Planning application no: 2021/94552

Land at, Barnsley Road, Denby Dale, Huddersfield HD8 8TS.

Erection of 53 dwellings and associated works

Comments for inclusion in the public consultation relating to the above planning application.

Appendix 1: Notes on Drainage Strategy

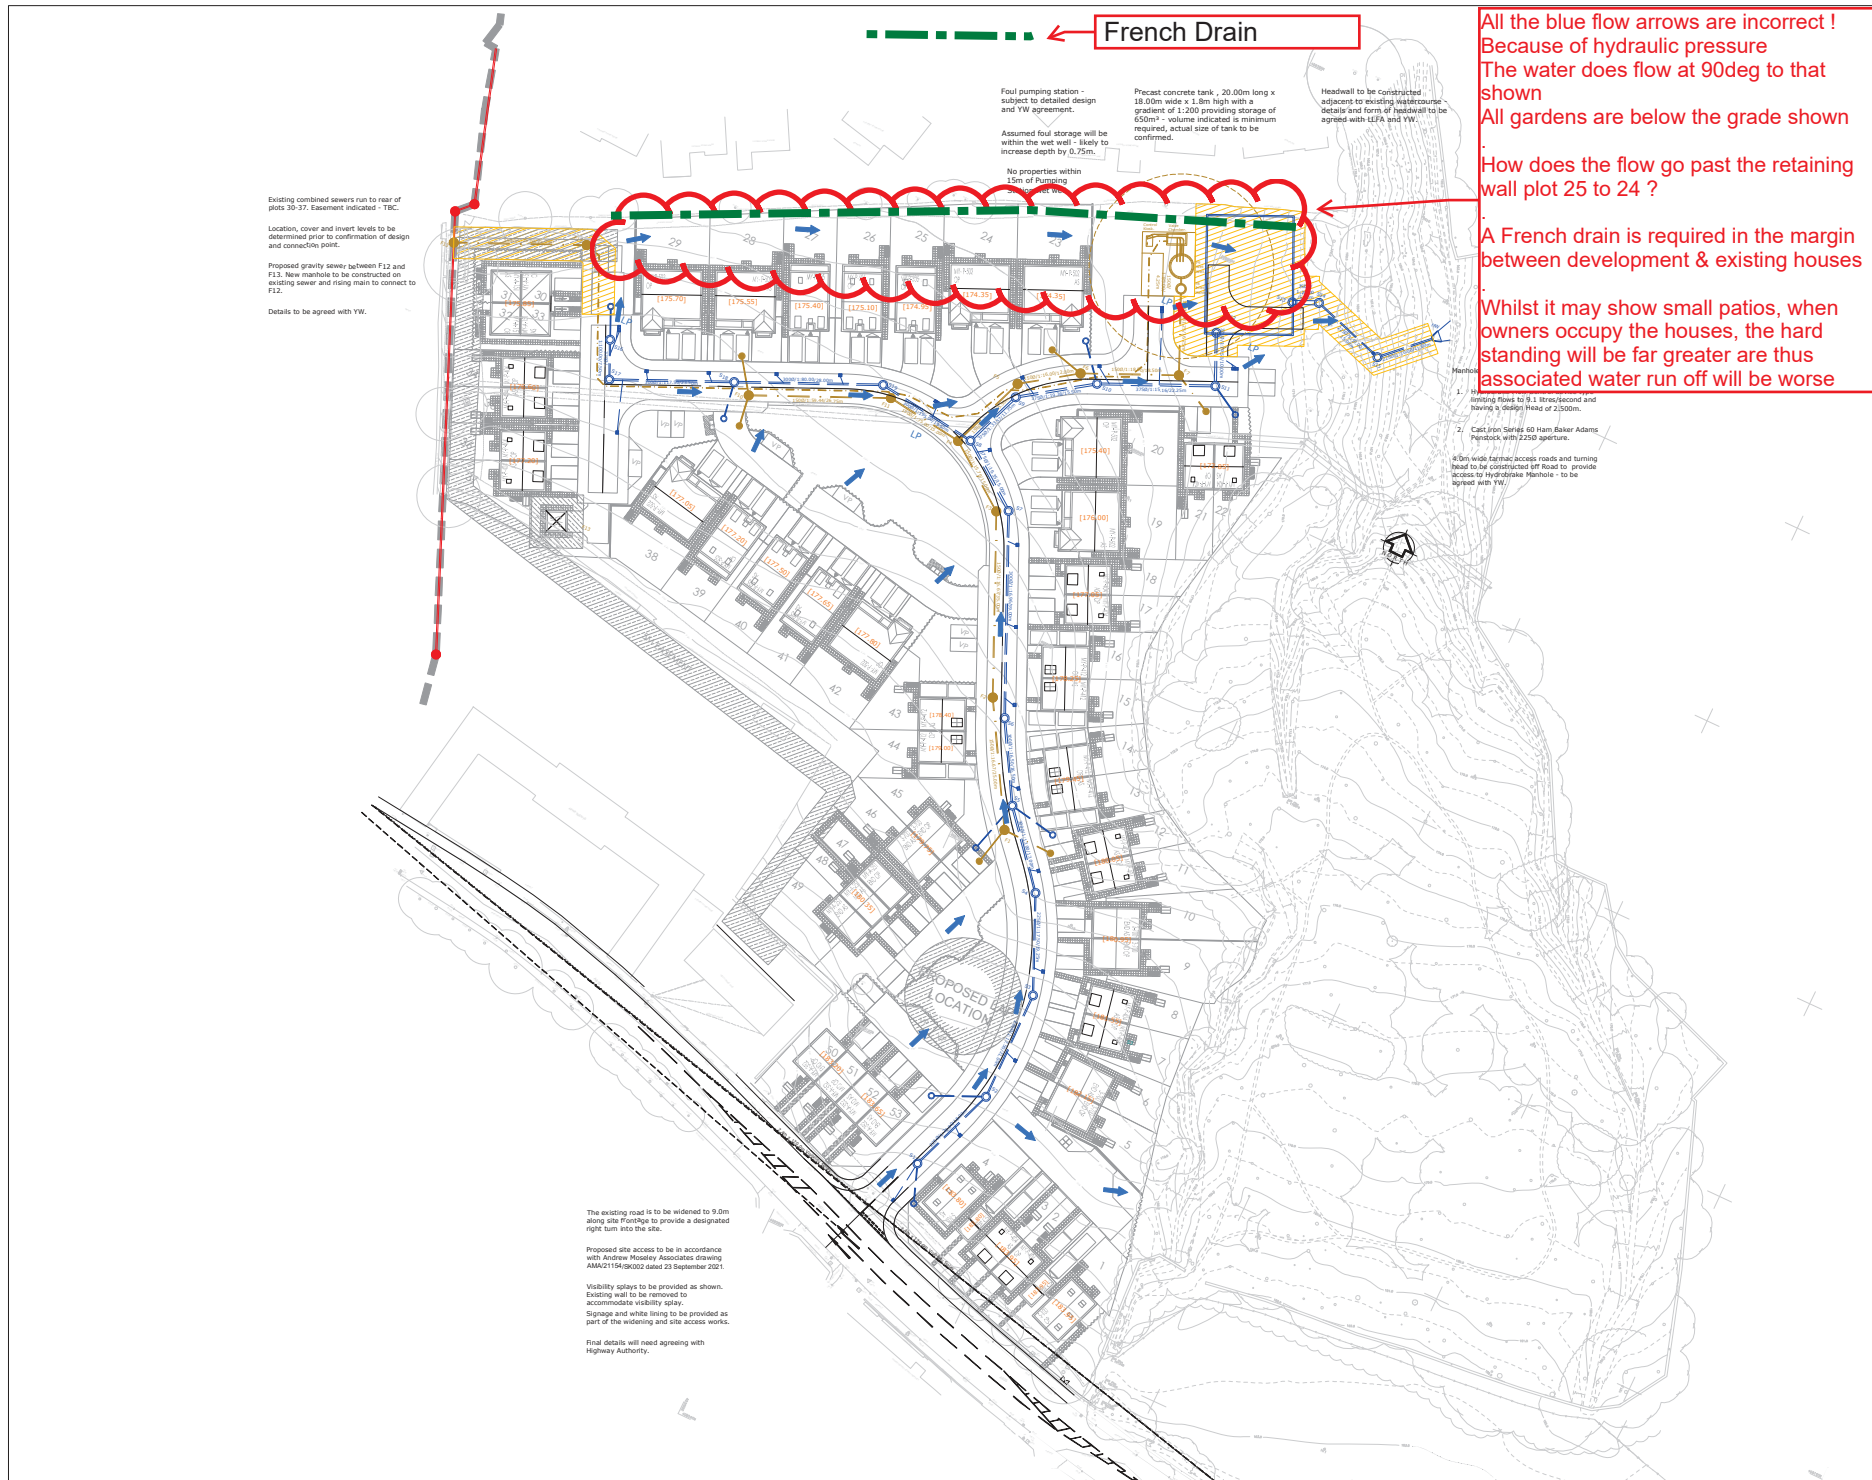
- c) The Drainage Strategy Plan (ref 5212-C-D-9-03, page 31 of Geo Structures Civils Flood Risk Assessment & Surface Water Management Strategy id908369) shows surface water running west to east along the northern boundary – see Appendix 1. For this to be effective the datum of the houses needs to be at 172.00

Given that the rear gardens of the proposed housing nearest this boundary slope markedly toward the northern boundary (more so than currently), it is impossible for surface drainage water to run in an easterly direction toward Tanner Wood as suggested on this plan.

Furthermore, boundary walls between the gardens of the new properties run north to south down toward the northern boundary. Hence, surface run off from this area will be further forced directly into the gardens of the existing properties north of this boundary.

A French drain running along the northern boundary is therefore a minimum requirement. (See Appendix 1) and the level of the new houses along the northern boundary should be lowered to reduce run off (See also section 4a below).

unacceptable tolerance especially after doing site detailed survey and pre-planning

The pump sewer route is not a straight line and there is no sealed pipeline manhole access points over this convoluted length to provide access to in the event of a blockage.

5. The drainage plan along the northern boundary is redrafted to show realistic flow directions in line with the topography of this area, i.e., into the gardens of neighbouring properties, and to include appropriate mitigation.

Appendix 2: Proposed Amend to Street Scene Schematic

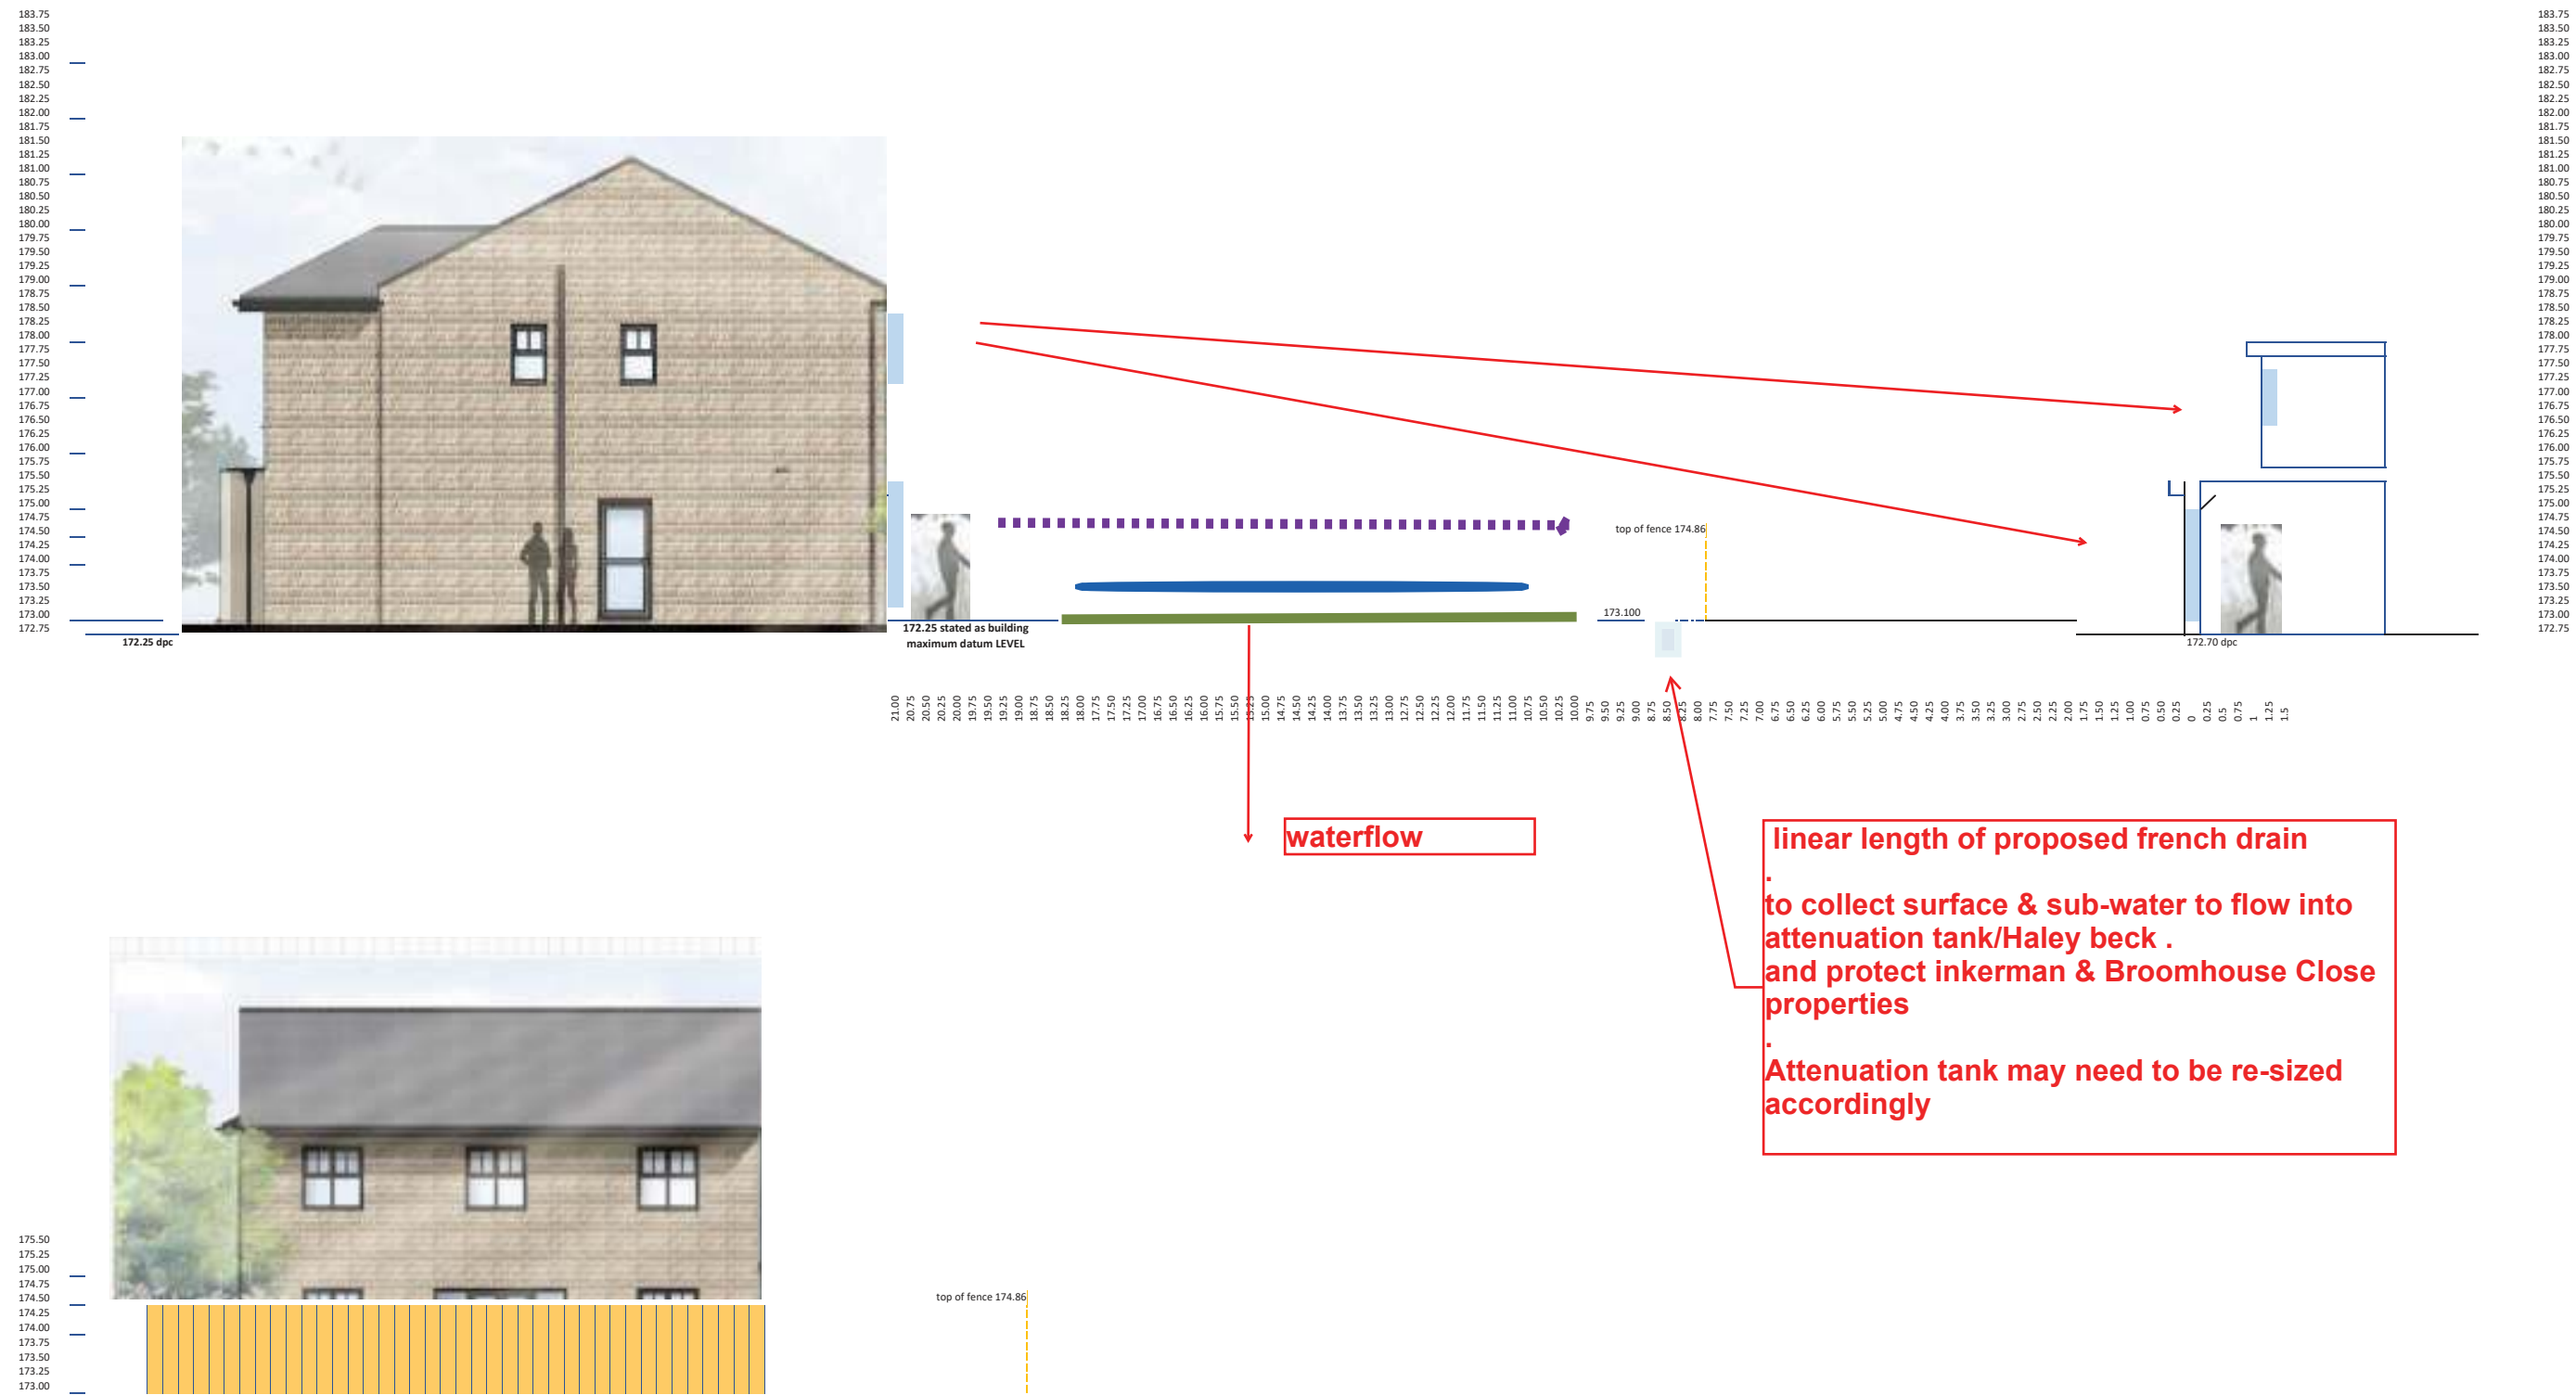
SHOWING proposed LEVELS and visibilty of habitable rooms that is contary to Kirlees Planning
policy REGARDING THE TOPOGRAPHY OF THE SITE as further distance away or making the

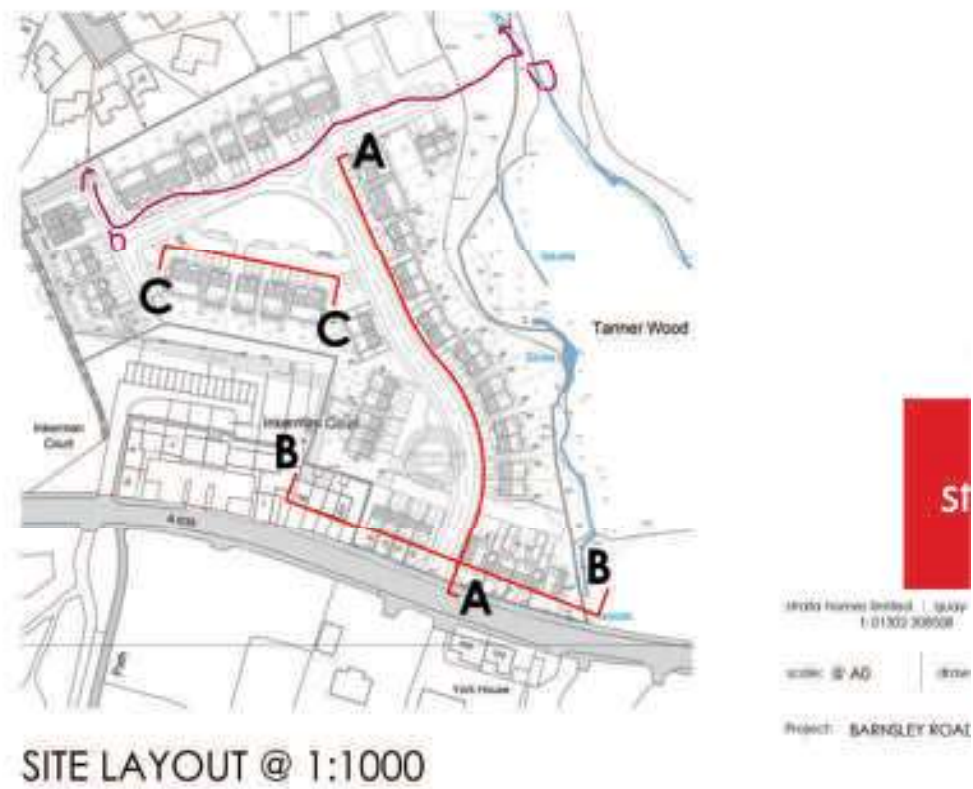
Similarly, the marked D-D & D1-D1 sections on Appendix 2 should be added to the plans to highlight the extent of overlook onto the existing properties on Inkerman Way and Broomhouse Close on the northern boundary.

Missing Elevation on plans Elevation DD

Required Elevation on plans Elevation D1-D1

- b. The correct location of the site boundary.
 - c. acceptable elevation tolerances of +/-5mm and not the current +/-600mm
 - d. the extended C-C1 elevation profile and the new D-D & D1-D1 elevation sections to properly illustrate the overlooking of existing houses on the northern boundary.

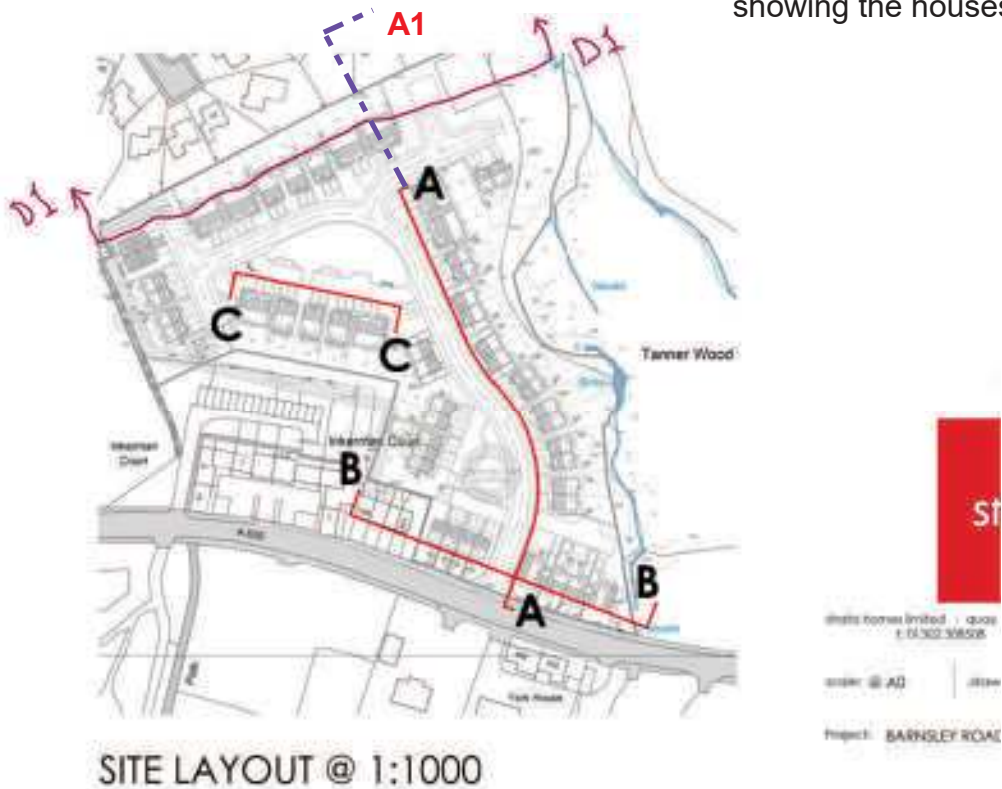
- e) Key street scenes are missing on the application drawings (See Strata Street Scene schematic: ref 21-CL2-SEGD-BRDD-10). Hence, the A-A section needs to be extended to A1 (See Appendix 2) in order that the houses in Broomhouse Close are shown with the associated overlook issues as, detailed later in section 4a of this commentary. Refer also to comments in (b) above

Also to add extension of view A-A to A1 clearly showing the houses in Broomhouse close

This D1-D1 view with proposed DPC level on would show the disparity in levels
